1 Products affected

Change of product design

Product Change Notification					PCN	PCN 2563 Adding Retaining Braket		
owner	creation date	release date	released by	change order	rev	page	D40 074 566	
wiedersa	15.06.2023	15.06.2023	muehlema		В	1 of 2	D10-074-566

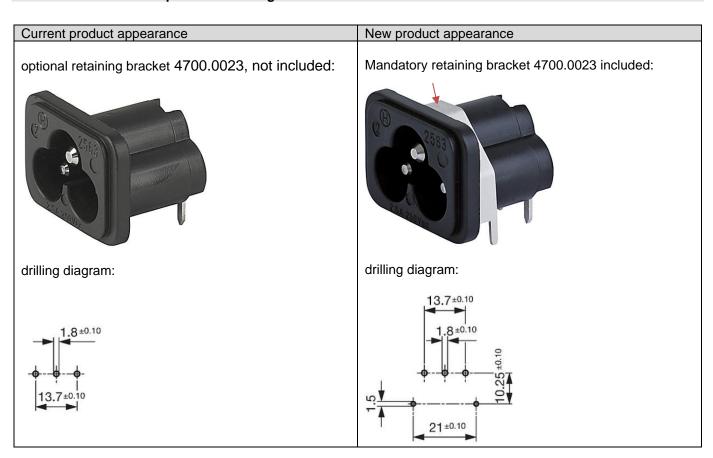
Retaining bracket is added as mandatory component. Before it was an optional accessory with part number 4700.0023.

Better fit and hold for PCB mount

\boxtimes	Form	Additional retaining bracket
\boxtimes	Fit	Verify the PCB drilling diagram and adjust your production process accordingly

The change takes effect in ww 38/2023 (Date code 2338 or higher on label). Parts on stock will be used upon depletion.
